VIRGINIA ELECTRIC AND POWER COMPANY
NORTH ANNA POWER STATION UNIT 2
INSERVICE INSPECTION PROGRAM
RELIEF REQUEST FROM ASME SECTION XI REQUIREMENTS
SAFETY INJECTION ACCUMULATOR VESSEL WELD EXAMINATION

**NORTH ANNA UNIT 2
RELIEF REQUEST FROM ASME SECTION XI REQUIREMENTS
SAFETY INJECTION ACCUMULATOR VESSEL WELD EXAMINATION**

2-SI-TK-1A, 1B and 1C - Safety Injection Accumulator Tank Welds

<u>Drawing No.</u>	<u>Weld No.</u>
VGB-2-1210	1, 2, 3, 4

VGB-21210

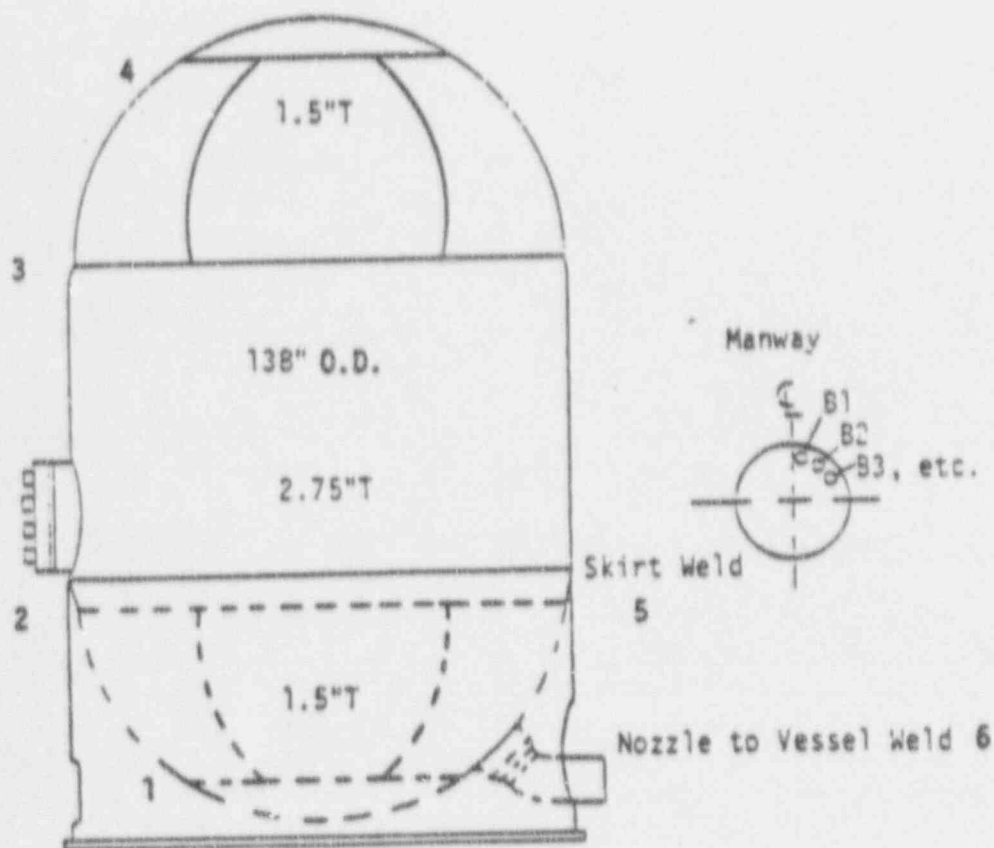
The safety injection accumulator tanks (2-SI-TK-1A, 1B and 1C) are ASME Class 2 vessels, welds 1, 2, 3 and 4 (shown in attached drawing) are required to be examined as previously described. The condition of these welds, however, prevents full volumetric examination coverage (i.e., Code Case N-460 requires at least 90% of the required volume be examined). The welds must be prepared by grinding the surface smooth to ensure complete examination coverage. Additionally, access to weld 2 is extremely limited due to the vessel skirt. Partial volumetric (UT) examinations have been performed on 2-SI-TK-1A for welds 1, 3 and 4 (0 degree - 33%, 45 degrees - 18% and 60 degrees - 43% coverage). Weld 2 was not examined because of its access problem.

As an alternative, it is requested that the first interval requirements to examine 2-SI-TK-1A, 1B and 1C as required by Category C-A, item C1.1 be considered complete based upon the partial examinations of welds 1, 3 and 4 and the 10 year hydrostatic test.
